Comments on EPA Region 8 and FLM Concerns Regarding BART Exemption Modeling for Montana- Dakota Utilities Company's R.M. Heskett Station Unit 2: August 2009 Update

Robert Paine
AECOM Environment (formerly ENSR)
Westford, MA
August 12, 2009

Figure 1: Terrain Features within Theodore Roosevelt National Park, South Unit

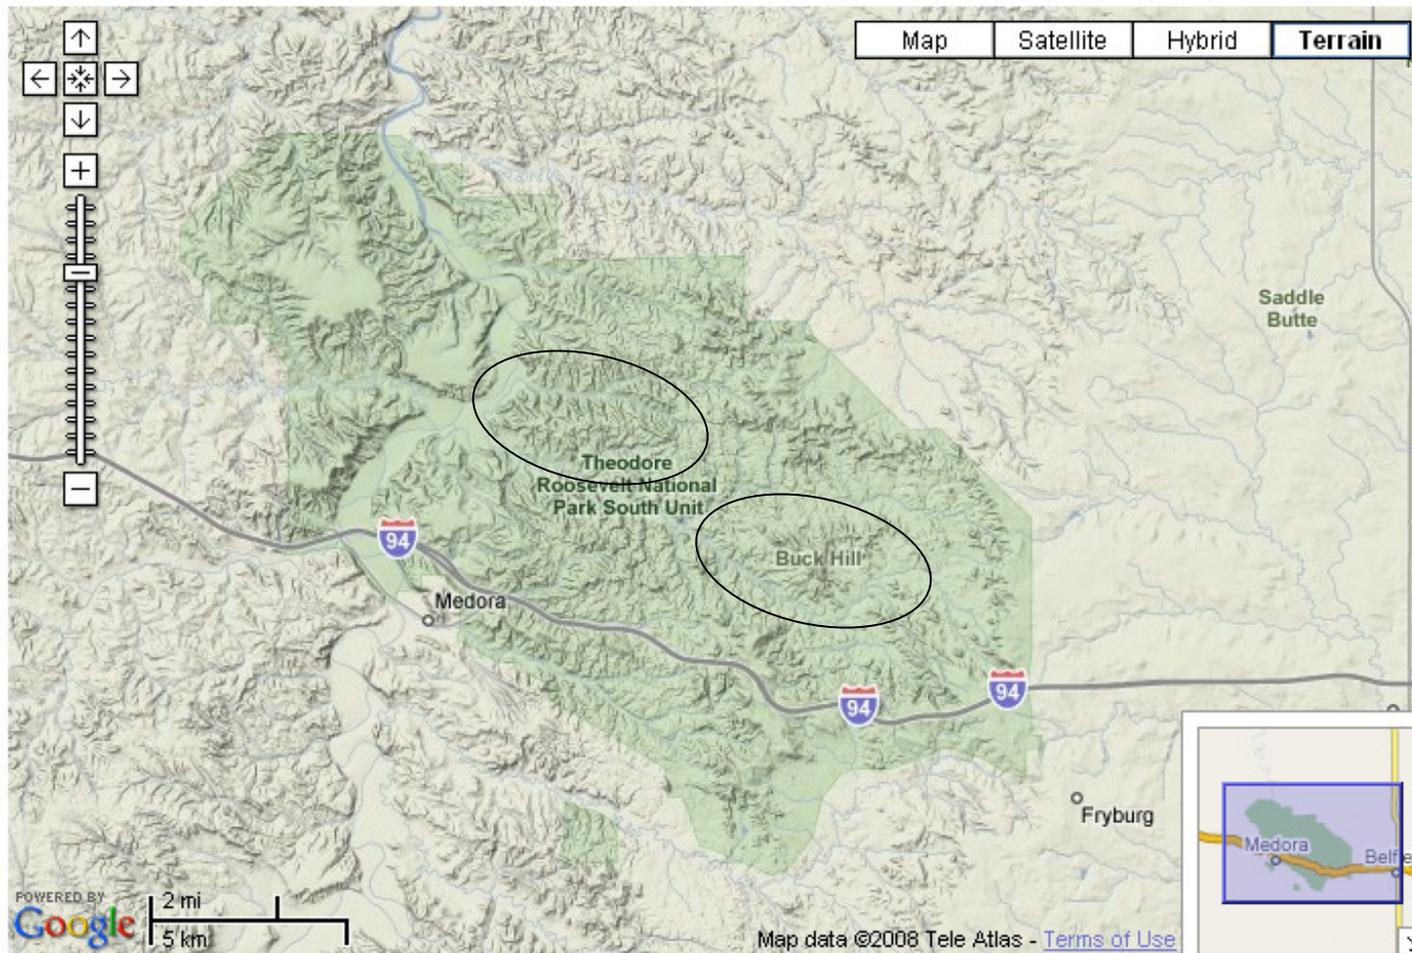
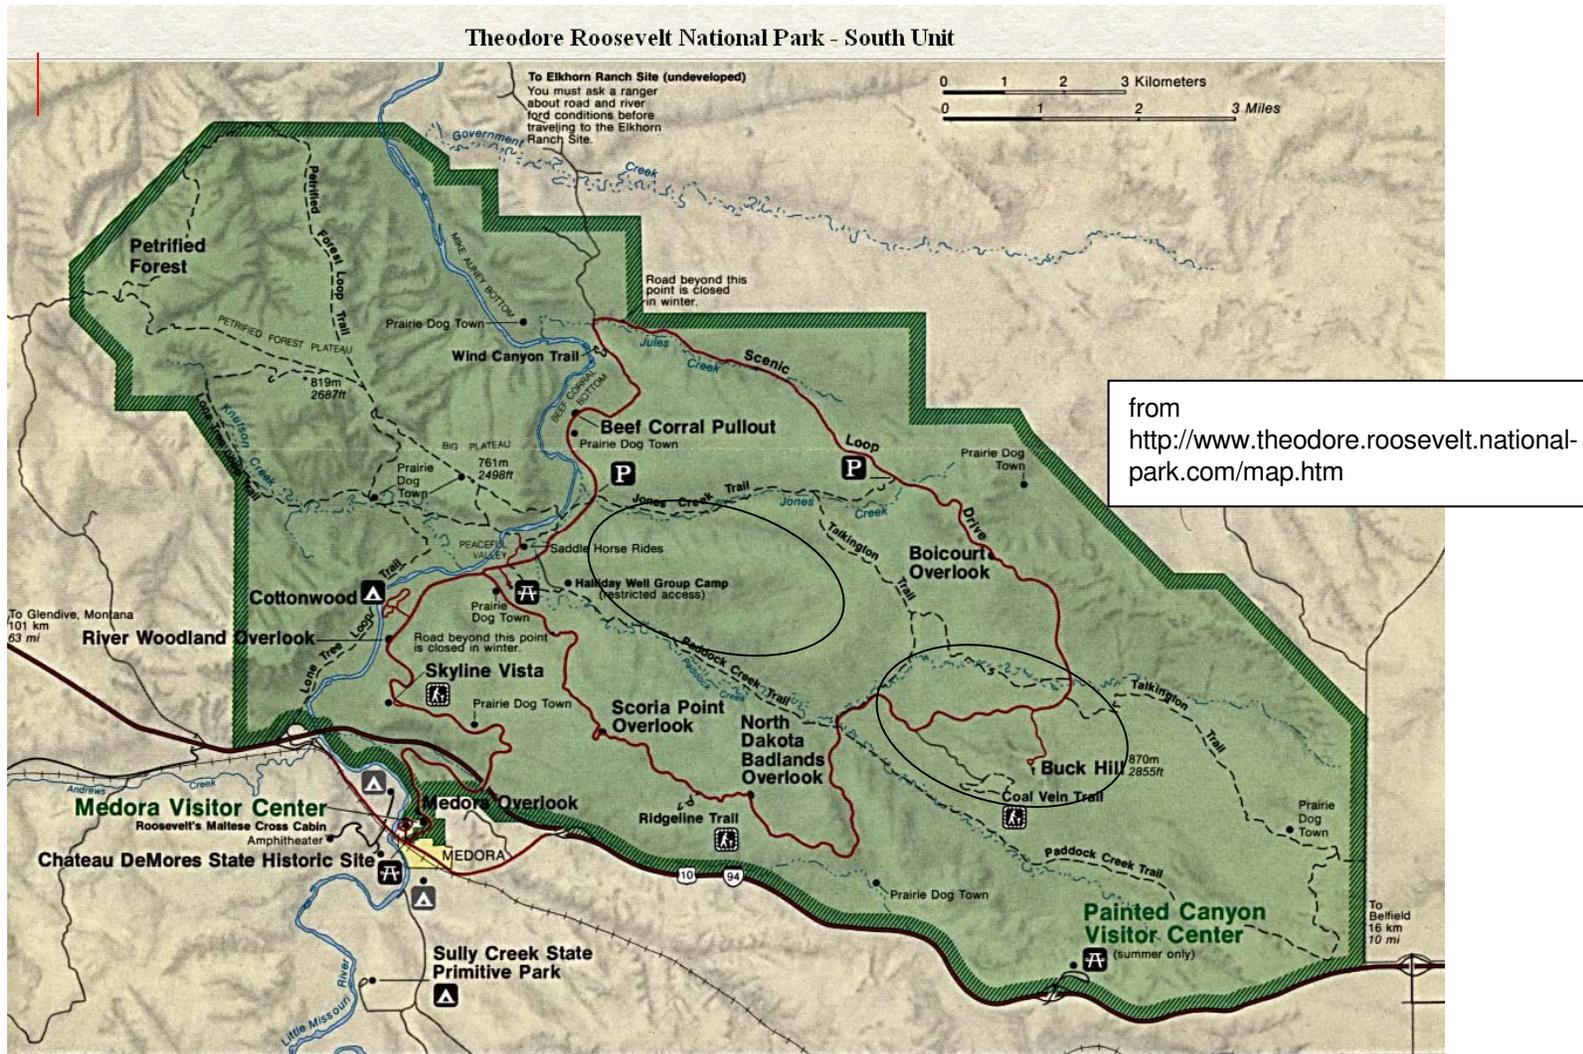
"We have concerns with ENSR's CALPUFF modeling. They reduce the CALMET/CALPUFF grid size from 3 km to 1 km. EPA has recently seen data indicating that CALPUFF may inappropriately reduce predicted concentrations with such grid size manipulation...Given that ENSR's refined results move Heskett from "subject-to-BART" to "exempt", a more robust discussion is necessary regarding why NDDH found ENSR's analysis "acceptable," including an explanation of why you think this approach will not lead to underestimates of visibility impacts."

The key aspect of this guidance is that CALMET needs to have at least 5 grid elements to adequately resolve terrain features. The terrain features within the TRNP South Unit are depicted in Figures 1 and 2. Figure 1 is included since it better represents the actual terrain features of TRNP, while Figure 2 depicts the actual park boundaries more accurately. Two typical areas are circled in both figures as examples of terrain features that are on the order of 5 km or less in size. This implies that a grid spacing as large as 3 km would excessively smooth out these terrain features. In compliance with the guidance provided by EPA through the TRC website's Frequently Asked Questions, ENSR used a 1-km grid spacing for the CALPUFF modeling to improve the accuracy of the model.

Figure 3: Comparison of Maximum Visibility Impact Predictions for Two CALPUFF Grid Sizes

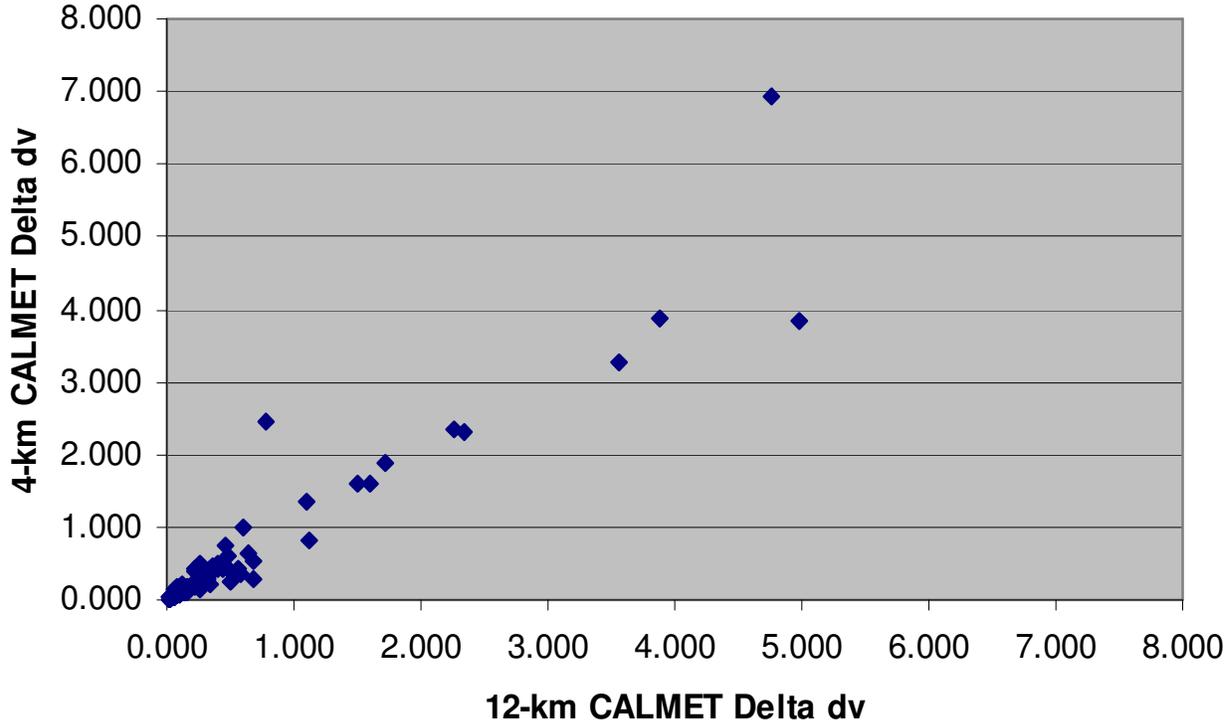
Recently, the FLMS have suspected that lower CALPUFF predictions are routinely generated by smaller grid spacing. We surmise that this is why it is referred to in the August 4, 2008 EPA Region 8 letter to NDDH as a “grid size manipulation”. ENSR recently discussed this issue with Tim Allen of the Fish & Wildlife Service. According to Mr. Allen, his discussions in 2008 with Joe Scire indicated that the use of a finer grid spacing was neutrally biased in providing either lower or higher CALPUFF impacts.

Regarding the issue that finer resolution always gives lower modeling predictions, this is clearly not the case. A summary of VISTAS modeling results for 26 sources at 90 source-Class I area combinations conducted previously by TRC shows this [see Figure 3]. Of the 90 cases, 47 cases showed higher max impact results with the finer grid resolution and 43 cases showed higher impacts with the coarse grid resolution. Given this result, using a fine resolution for selected Class I areas and coarse resolution for others (i.e., picking whichever produces the lower results) would probably not be deemed acceptable, since it is hard to argue the finer resolution result is better only in the cases when it produces lower impacts.
